RESTAURANT INTERIOR ALTERATIONS  
THE COMMODORE  
79 WESTERN AVENUE  
ST. PAUL, MINNESOTA

**From:** Larry Zangs [<mailto:Larry.Zangs@ci.stpaul.mn.us>]  
**Sent:** Friday, March 30, 2012 9:59 AM  
**To:** John R. Rupp  
**Cc:** Christine Rozek; Jim Bloom; John Skradski  
**Subject:** Building Plan Review and licensing questions for the Commodore at 79 Western for Monday's meeting

**Comments and Questions regarding the plans under review for permit at our office.**

SHEET NO. **A1**

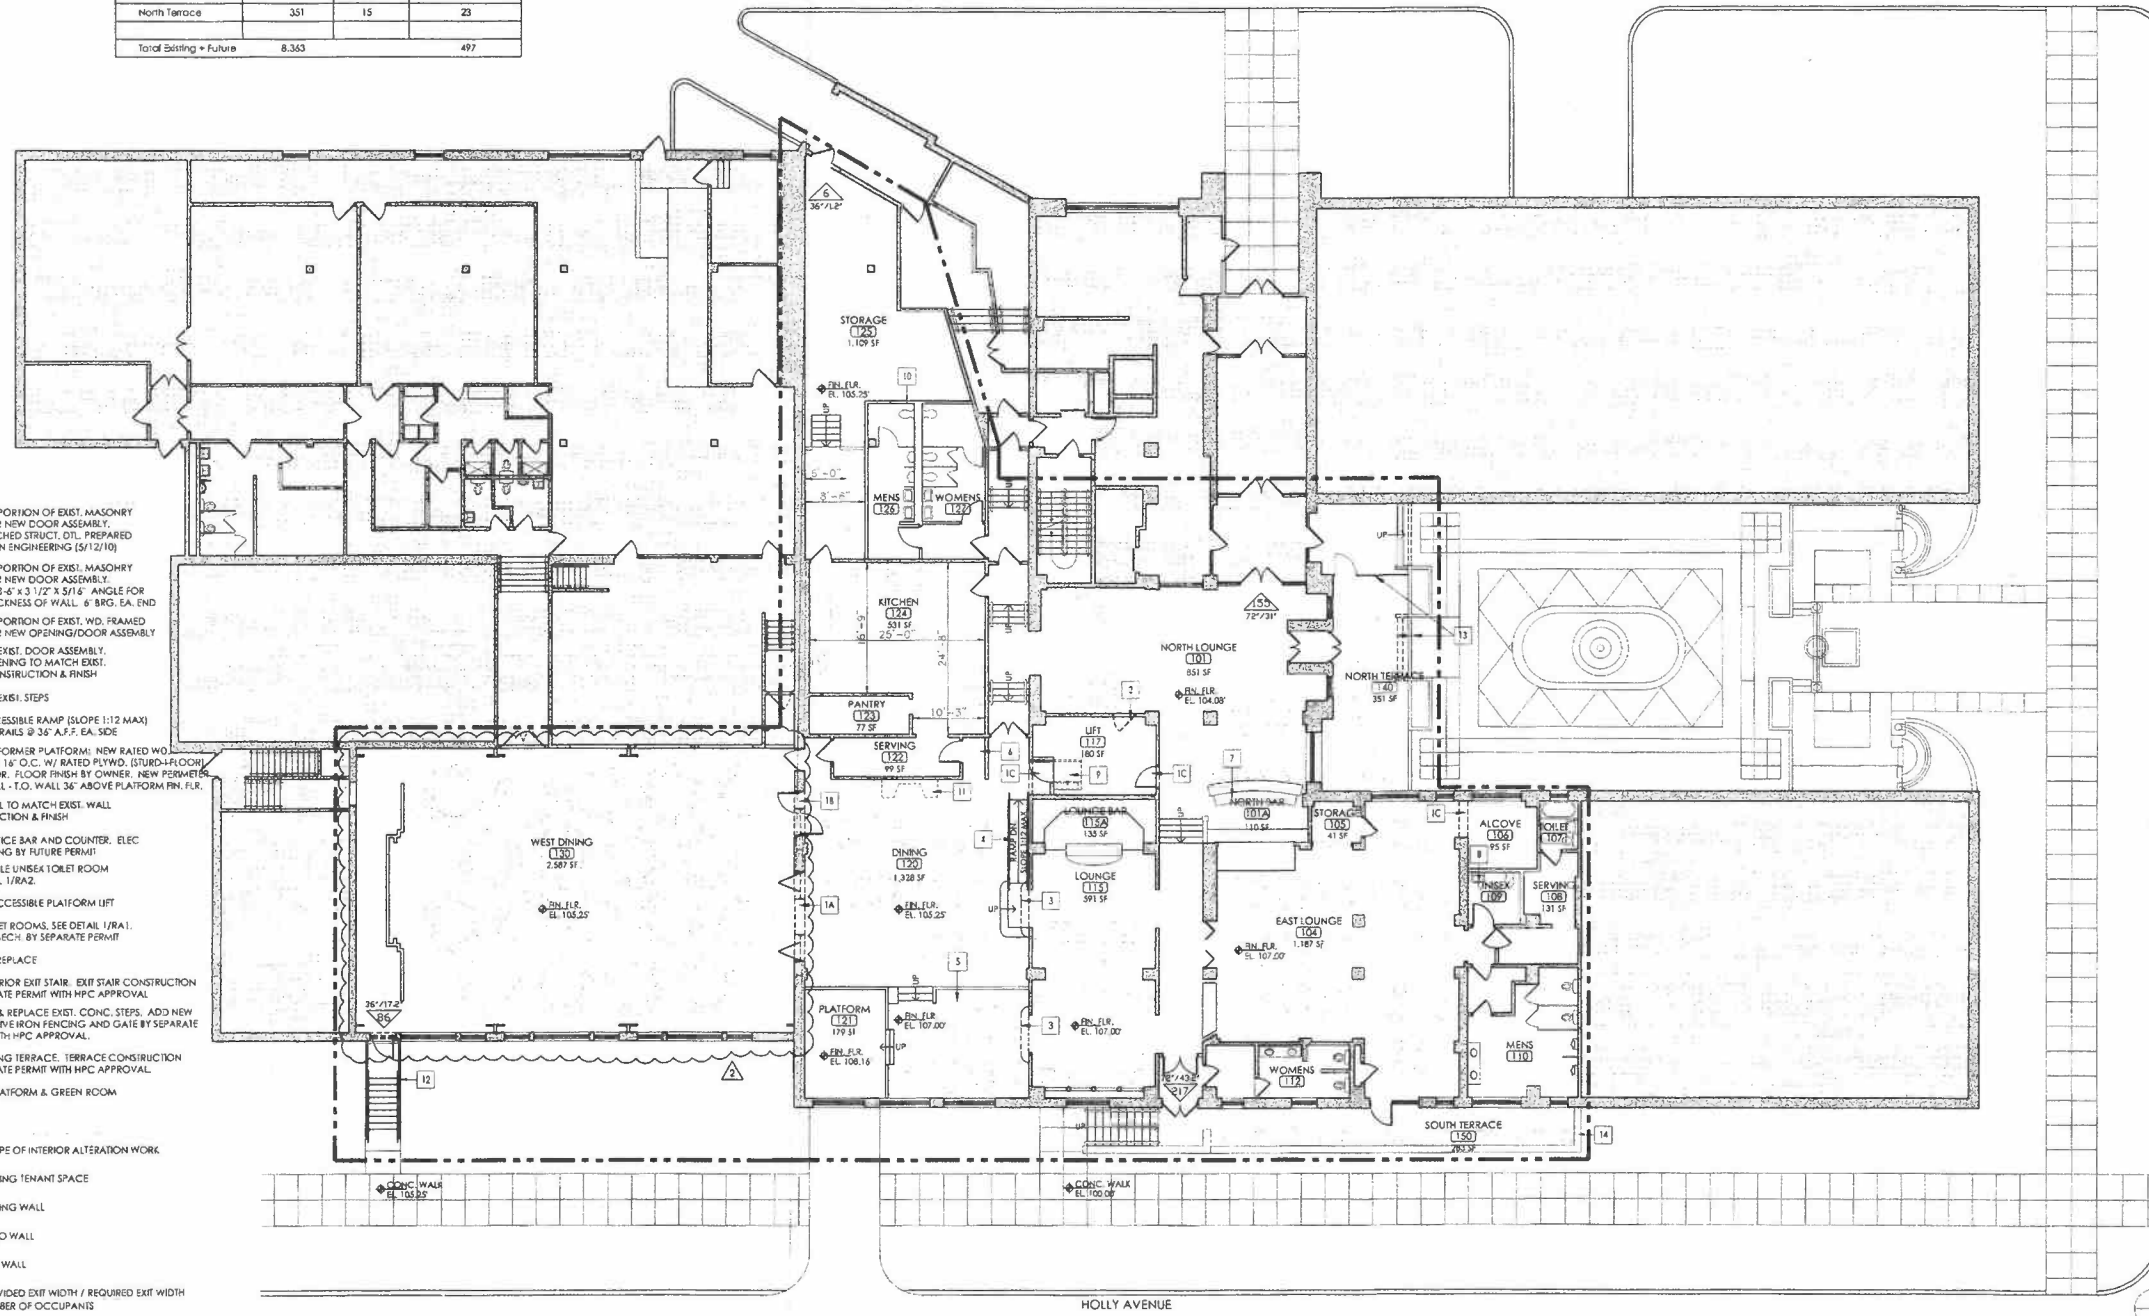
- o We need to know what your intention is for "future work" noted on plans.
- o The minor work being done (door openings, accessible ramp, miscellaneous wall construction) effects "future work" proposed .
- o See attached for liquor license conditions. Is there anything you are proposing for the Commodore that will required a modification to the license conditions

- o Plans are incomplete for information on wall types, door opening schedule, accessibility issues.
- o Key exiting plan from the building
- o Need SAC determination letter from Met Council before building permit can be issued.
- o We will need to discuss note on plans about future building expansion.

- o Architect has not signed the drawings.
- o Architect has not submitted a code review of the whole building.
- o Plans are incomplete for information on wall types, door opening schedule, accessibility issues.
- o Need documentation that only one exit will be allowed.
- o Need SAC determination letter from Met Council before building permit can be issued.

1 A1 1ST FLOOR PLAN

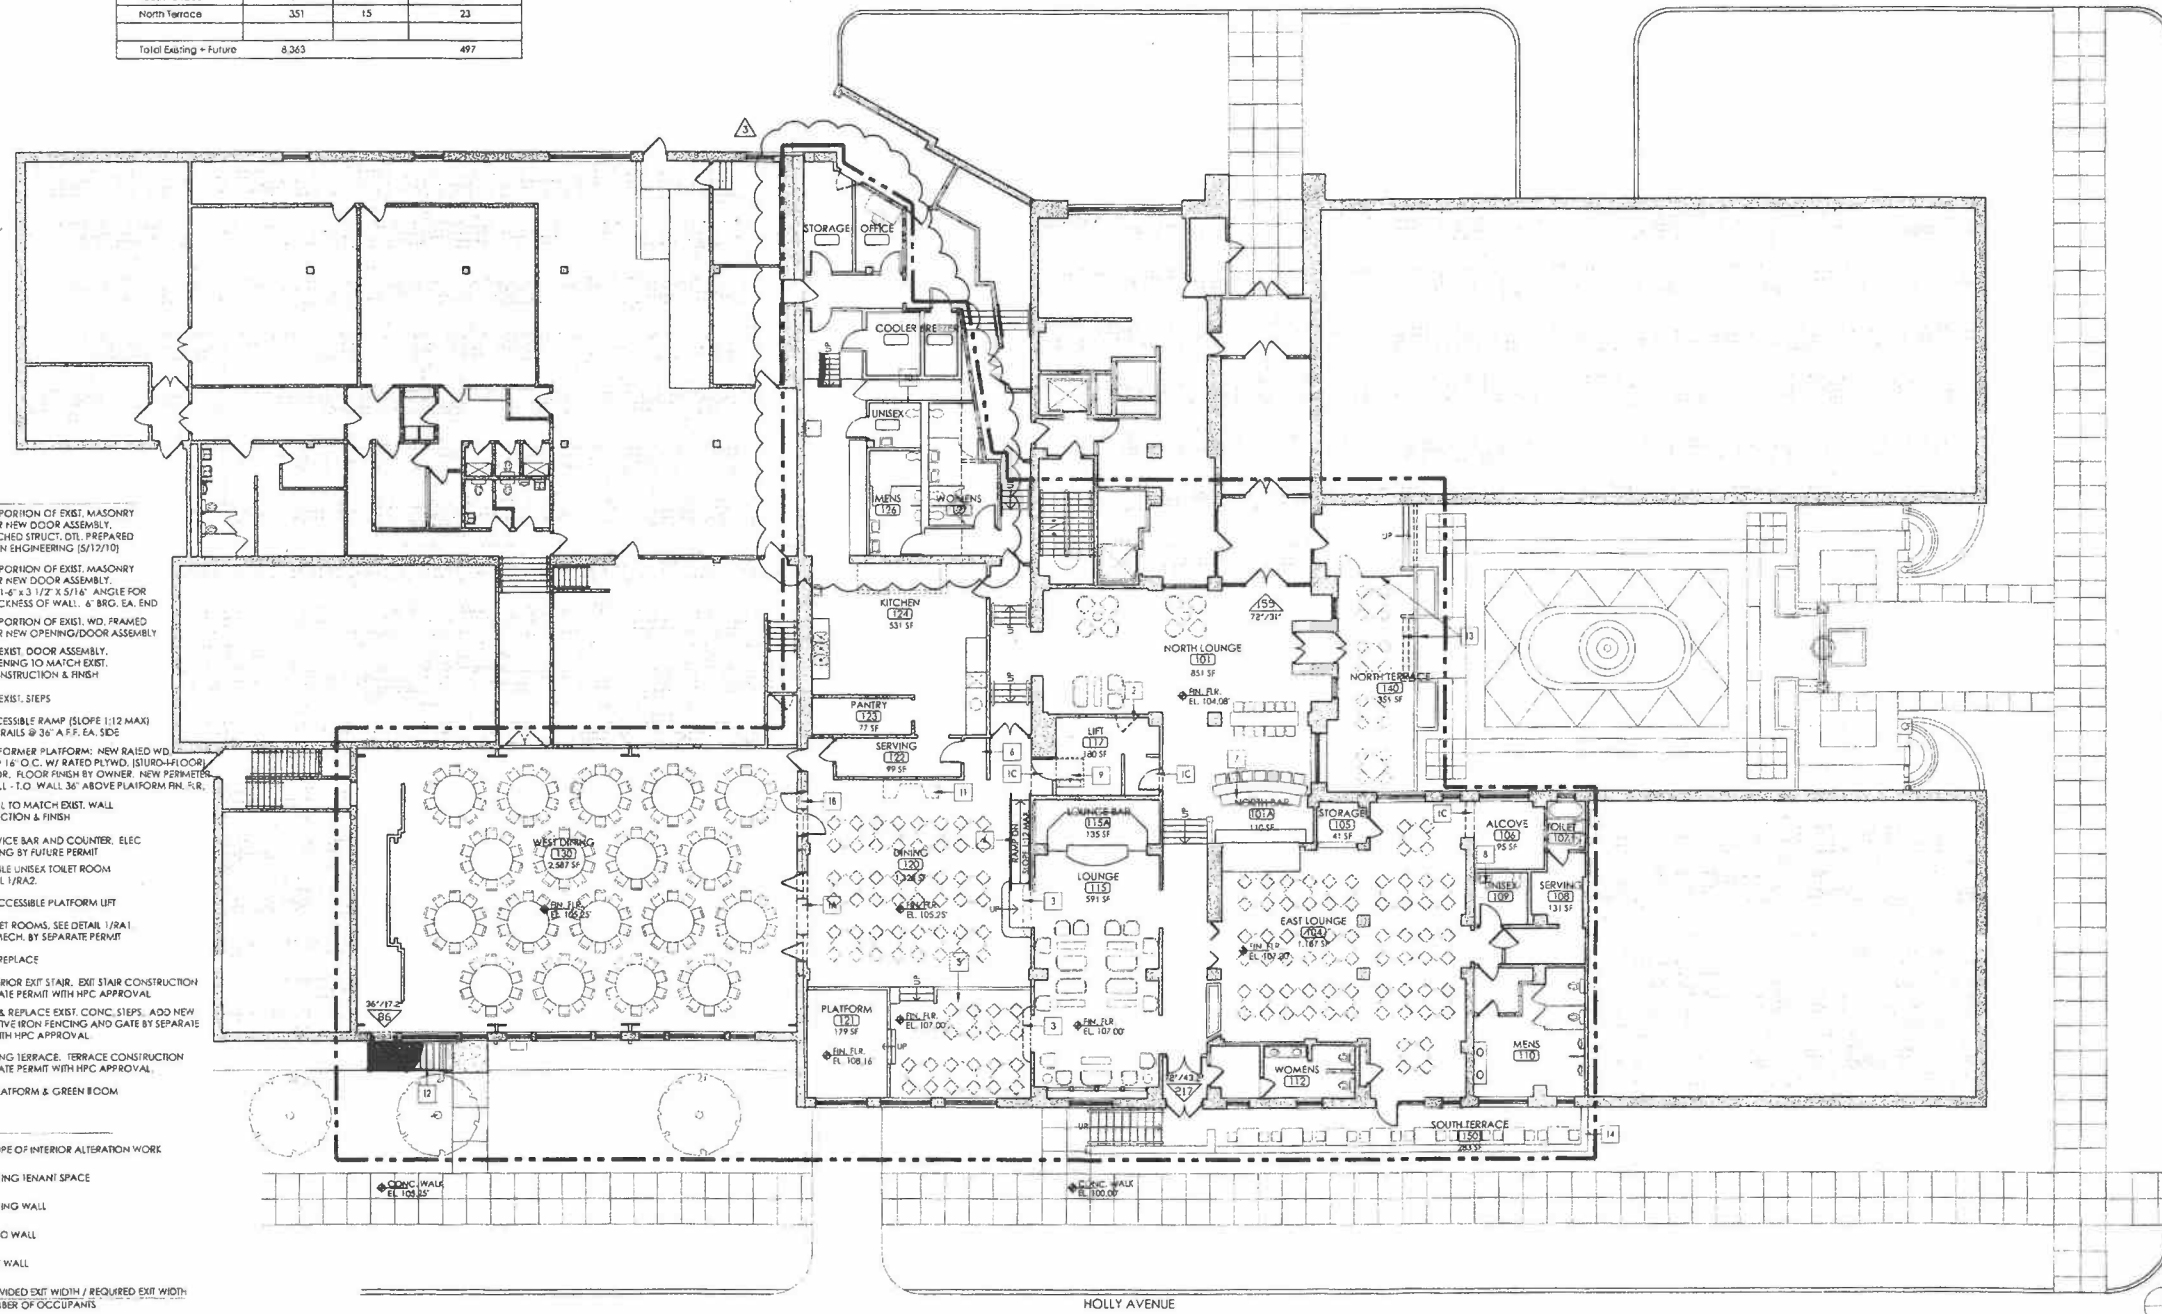
1. At West Dining 130, add wall.
2. At West Dining 130, delete Note 7.
